HARRISON HILLS CITY SCHOOL DISTRICT
HARRISON COUNTY, OHIO
HARRISON HILLS CITY SCHOOL DISTRICT OUTDOOR CLASSROOM

ADDENDUM #1
November 9, 2022

THRASHER PROJECT #030-10454

C2.02

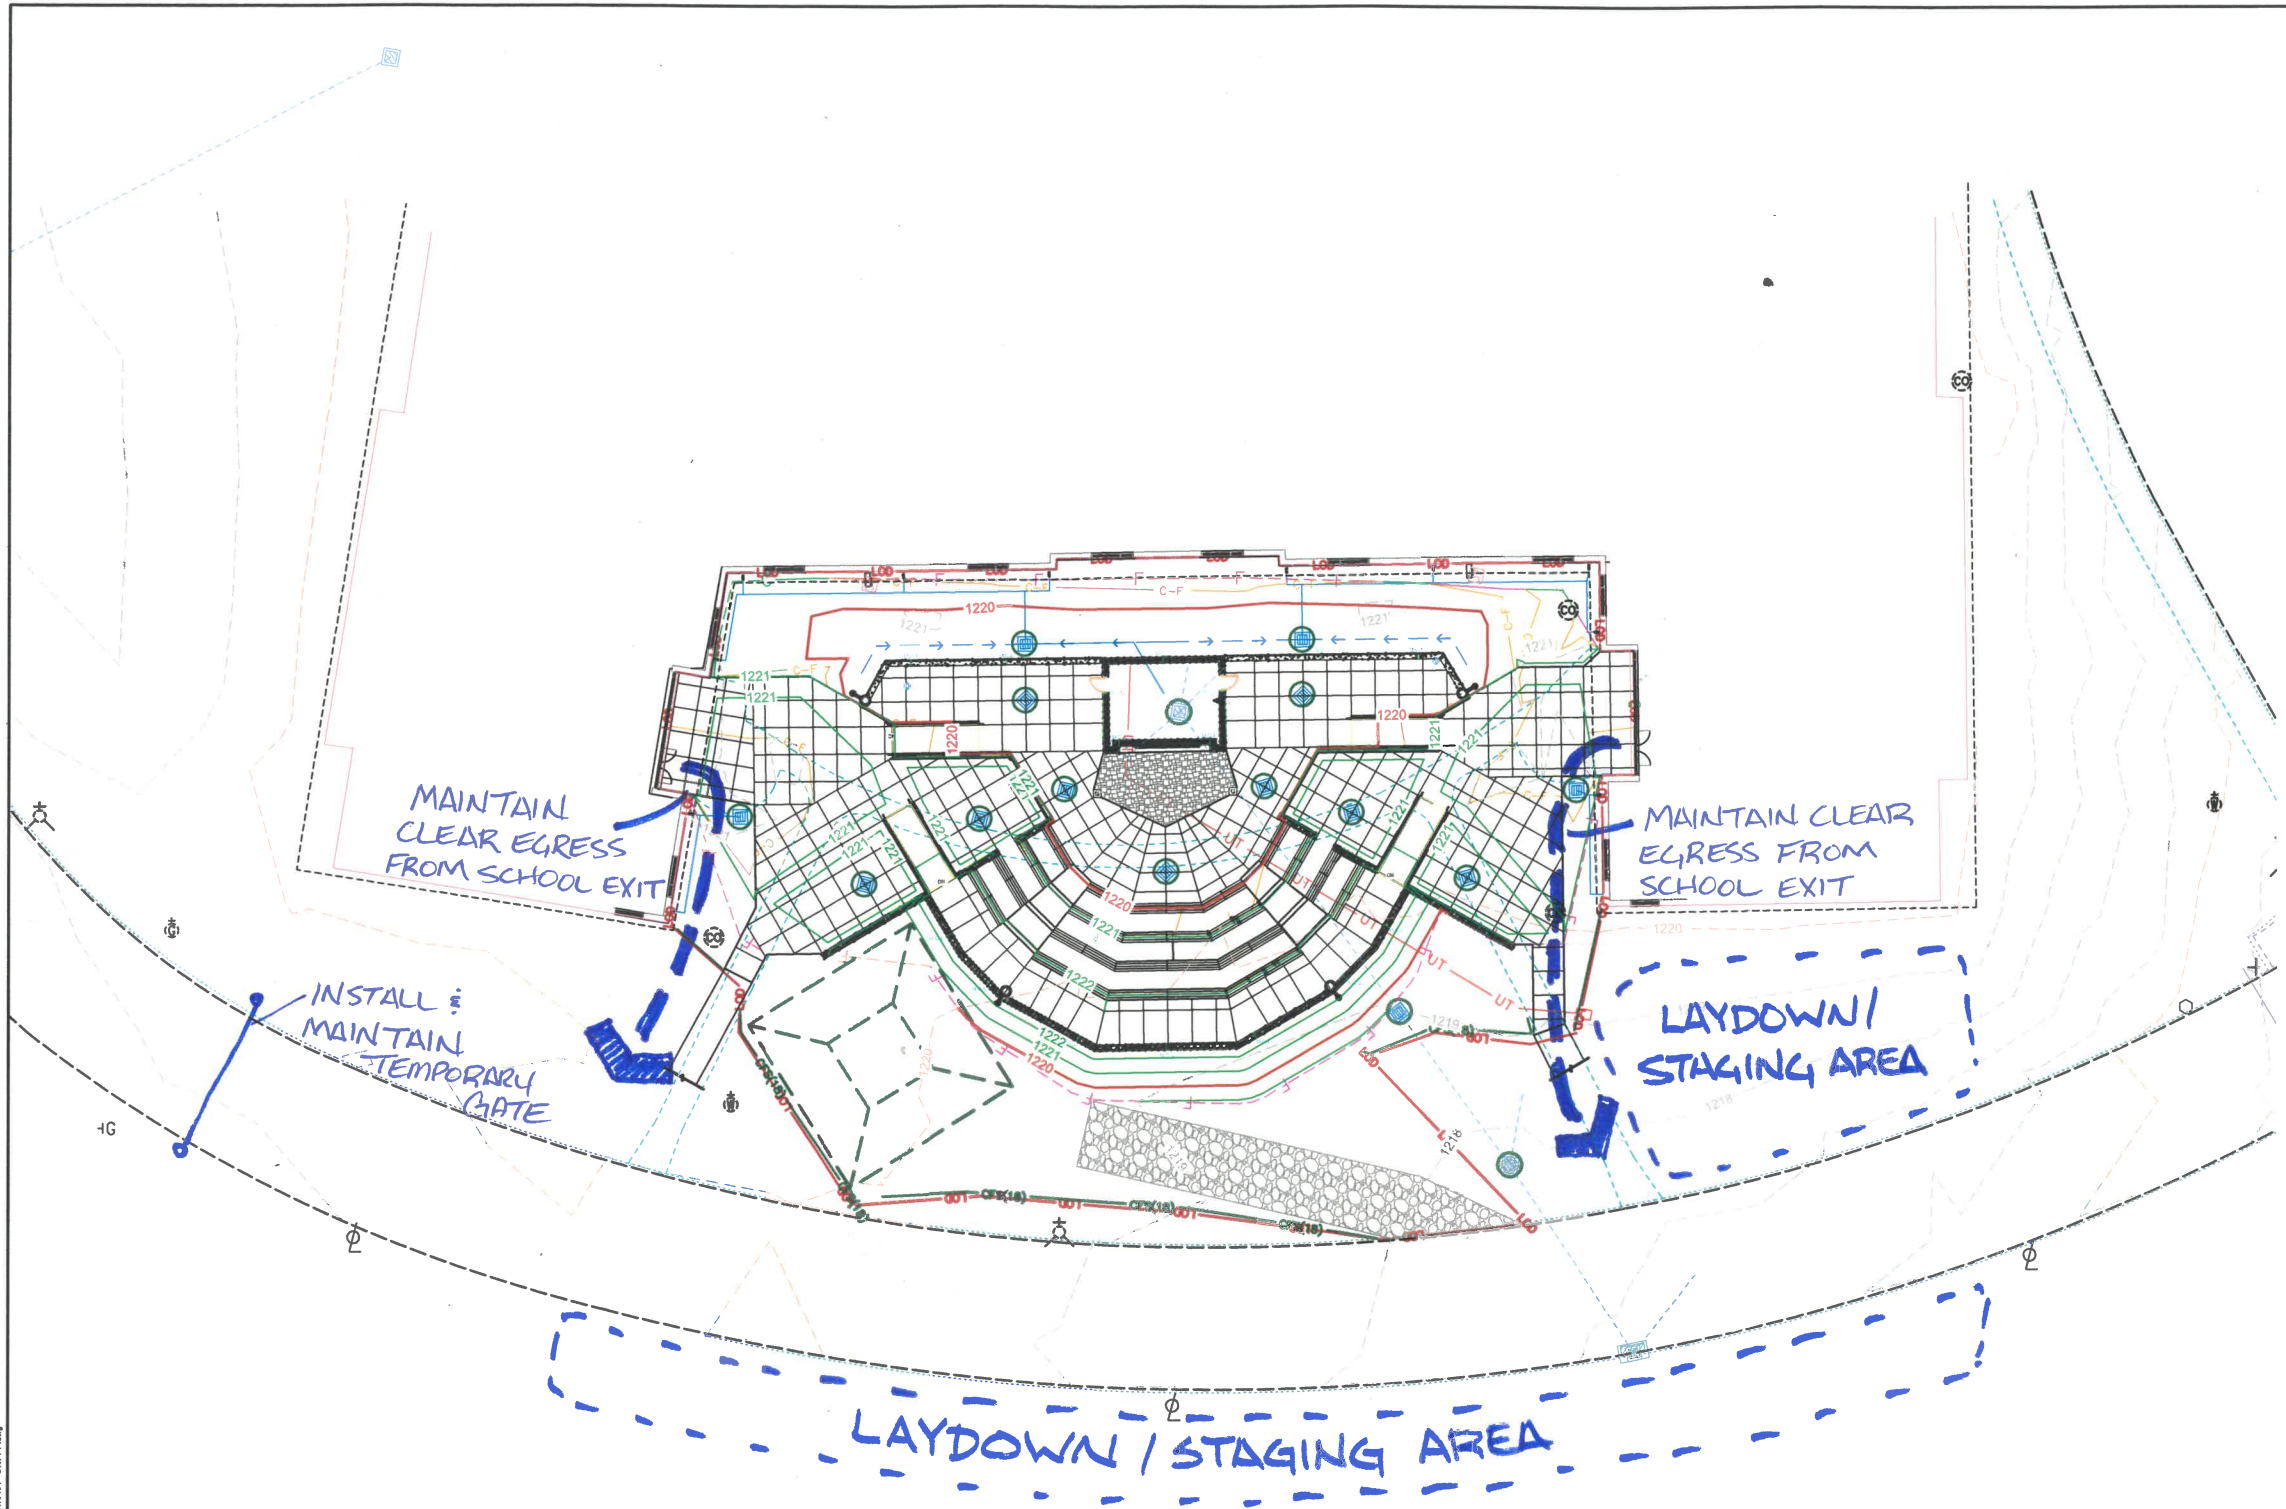
1. Sheet C2.01, Site Description Notes, Note 9 Anticipated Start/End Dates, **REVISE** to read as follows; "9.1 December 2022/June 2023".
2. Sheet C2.02, **ADD** this sheet as attached to this Addendum.
3. Sheet S500, **OMIT** Detail 11/S500.
4. Sheet A2.01, Markerboard Legend, **REVISE** dimensions to read, 4'-0"T x 8'-0"W.
